## ST. TAMMANY PARISH

**Addendum No.:** 2

**Bid#:** 24-47-2

**Project Name:** River Oaks Building & Well Improvements

PROJECT No.: TU23000160  
RIVER OAKS  
SLIDELL, LOUISIANA  
BUILDING & WELL IMPROVEMENTS  
RIVER OAKS  
STAIR PLAN & ELEVATION

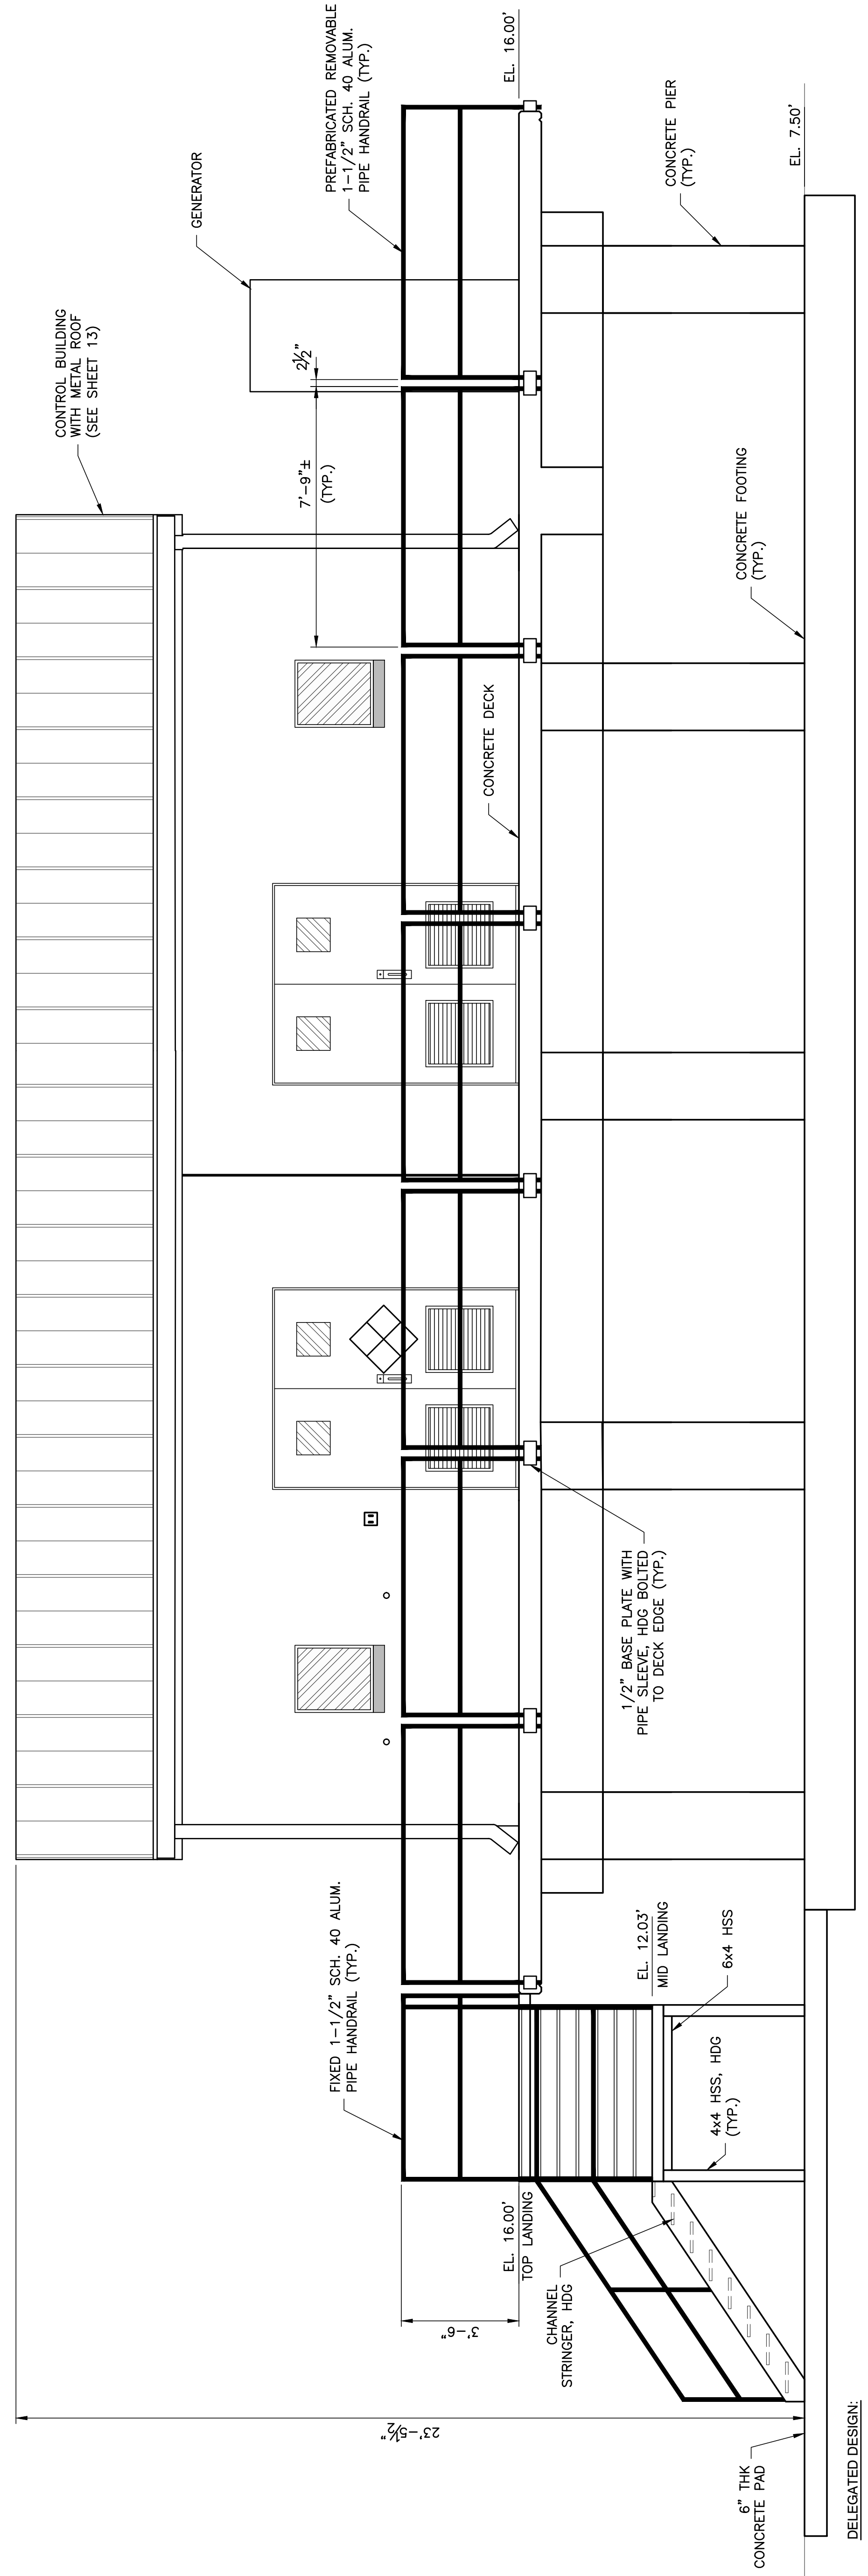
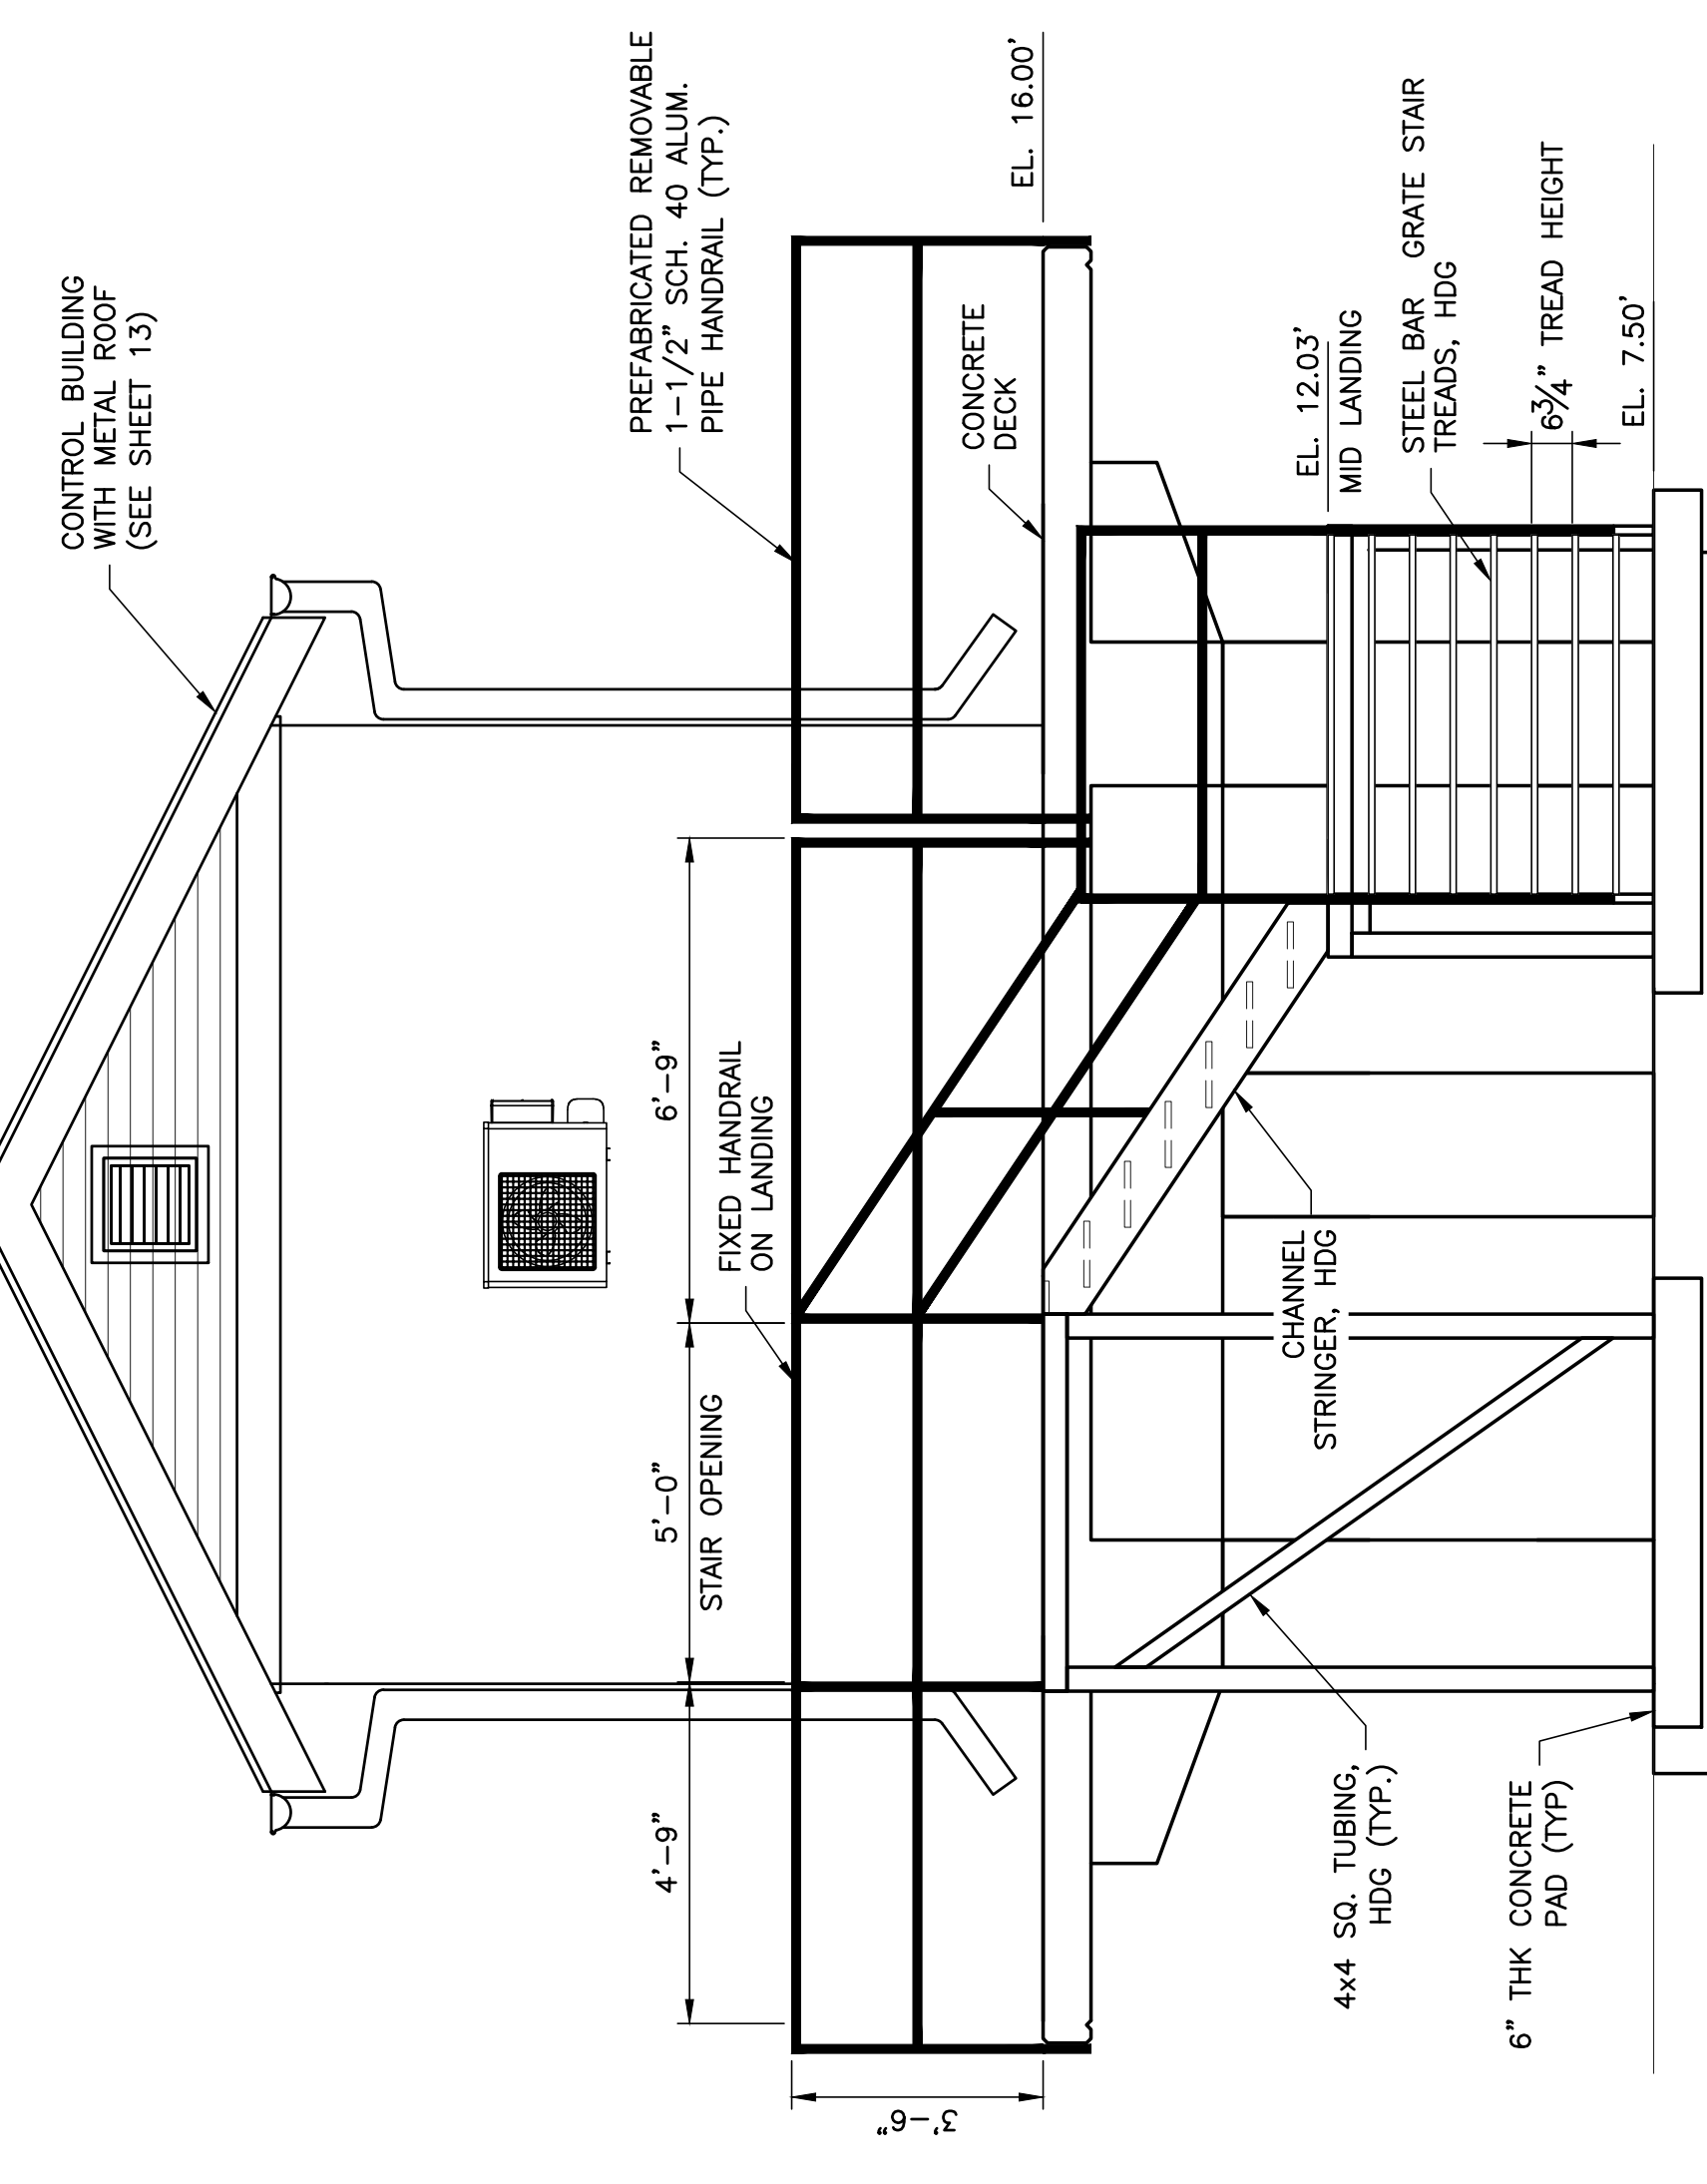
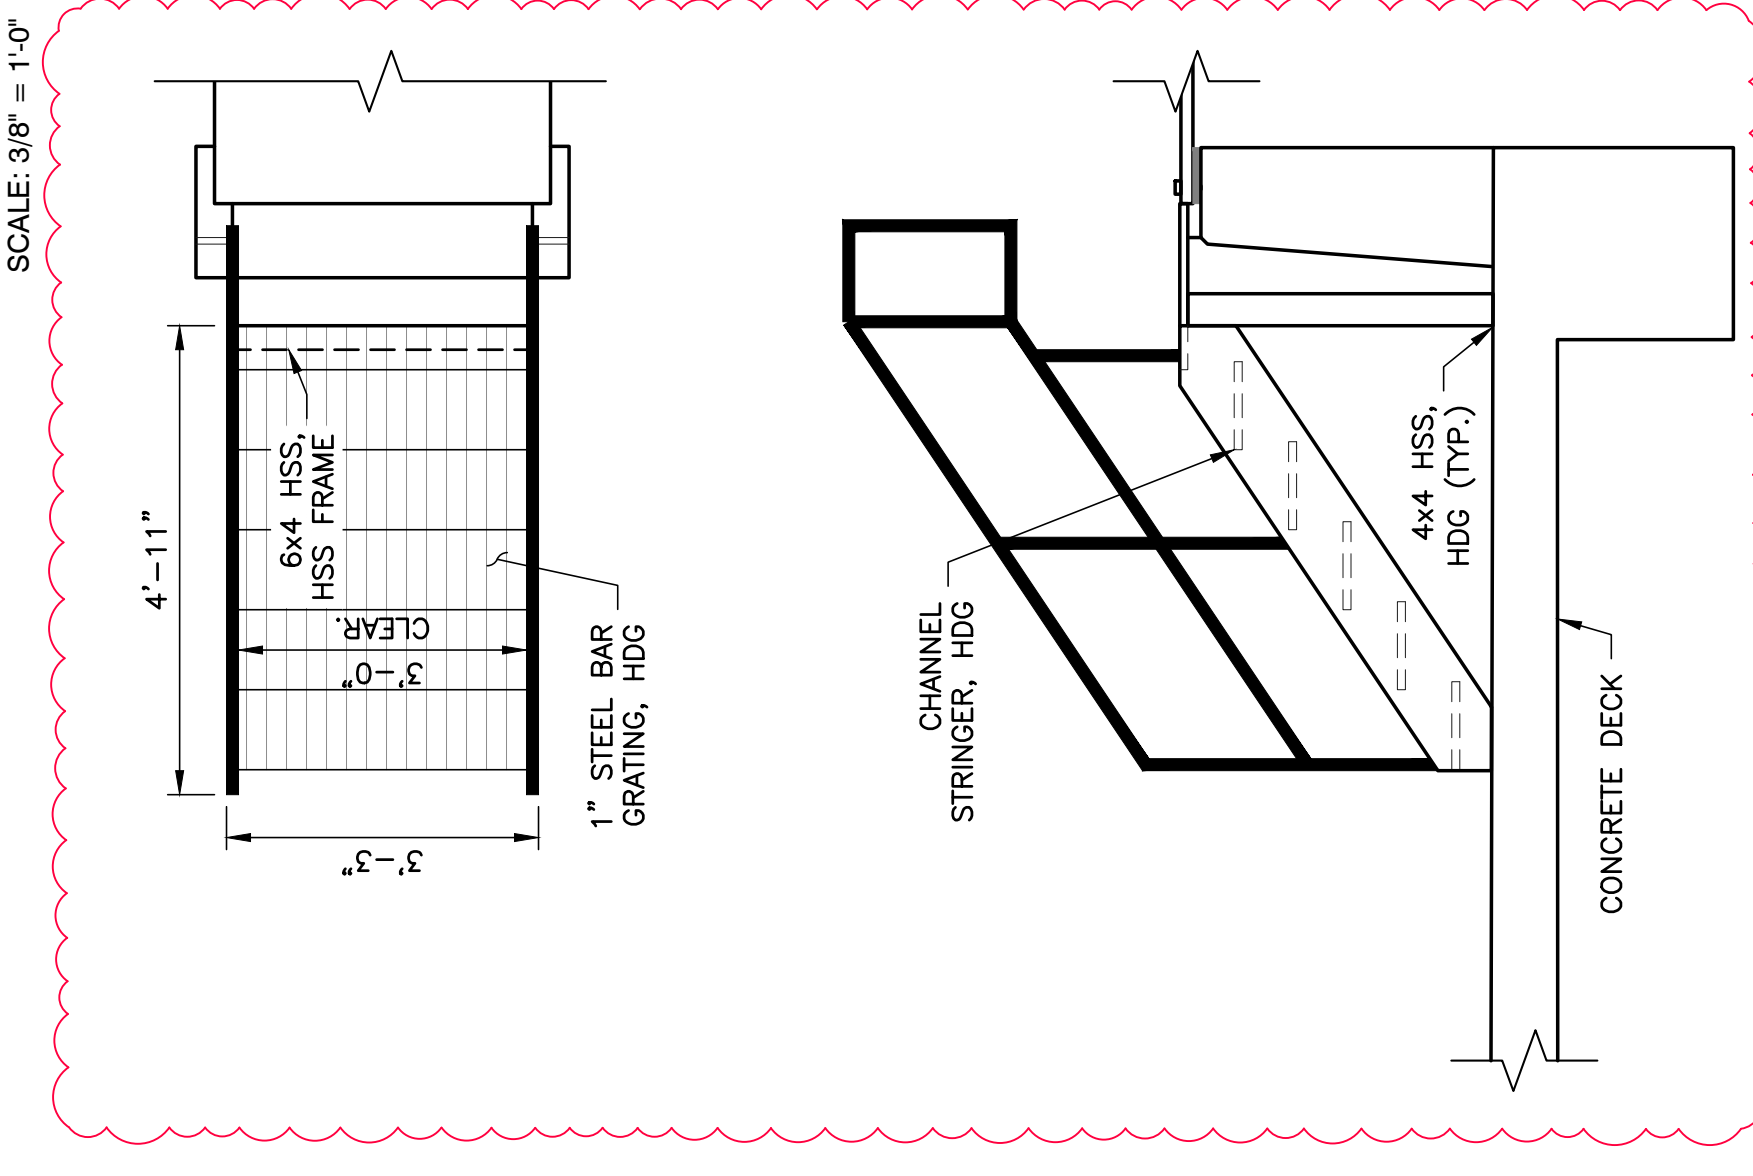
No.	DESCRIPTION OF REVISION	DATE
2	ADJUSTED ELEVATION OF WELL ACCESS STAIR	11.19.24
